# Access Compliance Report

## Public Rights-of-Way

### (Curb Ramps)

Intersection ID: 10021652	Main Street: BRANDON_FOREST_DR	Cross Street: N/A	Location: S
ADA ID: 2C56D0D950D7	Ramp Type: Directional1	Initial Pass/Fail: Fail	Overall Compliance: No
Severity Score: 1.25			
Codes/Mitigation Info/Possible Solution		Field Measurements/Component Compliance

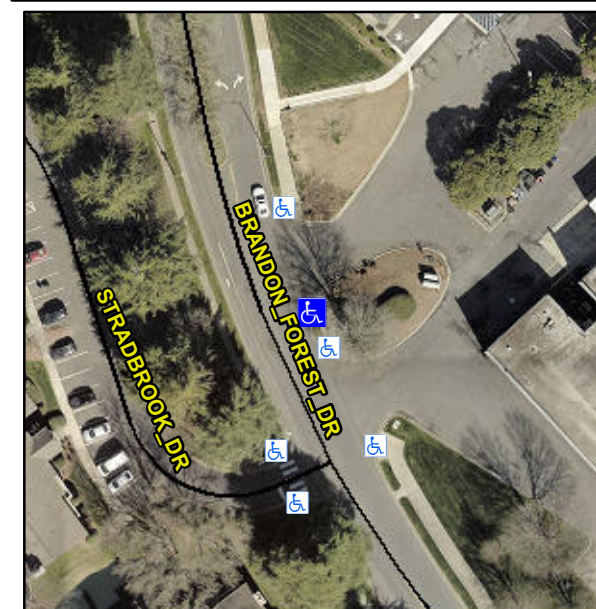
**R304.5.3**

Compliance	Description	Data	Compliance	Description	Data
N/A	Ramp Length (in)	104.0	N/A	Grade Break?	N/A
Yes	Ramp Width (in)	97.0	N/A	Grade Break Slope (%)	0.0
Yes	Ramp Slope (%)	5.6	N/A	Grade Break XSlope (%)	0.0
No	Ramp XSlope (%)	2.5			
N/A	Flare Type LT	N/A	N/A	Flare Type RT	N/A
N/A	Flare Slope LT (%)	N/A	N/A	Flare Slope RT (%)	0.0
N/A	Flare Traversable LT?	N/A	N/A	Flare Traversable RT?	N/A
N/A	Landing Length (in)	0.0	N/A	DWS Provided?	N/A
N/A	Landing Width (in)	0.0	N/A	DWS Contrast?	N/A
N/A	Landing Slope (%)	0.0	N/A	DWS Length (in)	N/A
N/A	Landing X Slope (%)	0.0	N/A	DWS Full Width?	N/A
N/A	Landing Curb? (Y/N)	N/A	N/A	DWS Offset LT (in)	N/A
N/A	Shared Landing?	N/A	N/A	DWS Offset RT (in)	N/A
N/A	Gutter Ponding?	0.0	N/A	Gutter Slope (%)	N/A
N/A	Gutter Lip Ht (in)	0.0	N/A	Gutter X Slope (%)	N/A
N/A	Painted X Walk1?	No		Road Slope (%)	4.0
	X Walk 1 Direction	To NW		Road X Slope (%)	4.2
	X Walk 1 Width (in)	N/A		Clear Space?	N/A

X Walk 1 Slope (%)	4.0	N/A	Clear Space to XWalk (in)	N/A
	X Walk 1 X Slope (%)	4.2	N/A	Storm Grate/Utility Hazard?	N/A
N/A	Ramp inside XWalk1?	N/A		Storm Grate/Utility Type	
N/A	Any Obstructions?	N/A			N/A
	Obstruction Type		Yes	Surface Condition? (G/P)	Good
			N/A	Curb Slope (%)	12.1

**Remove & Replace Entire Ramp.**
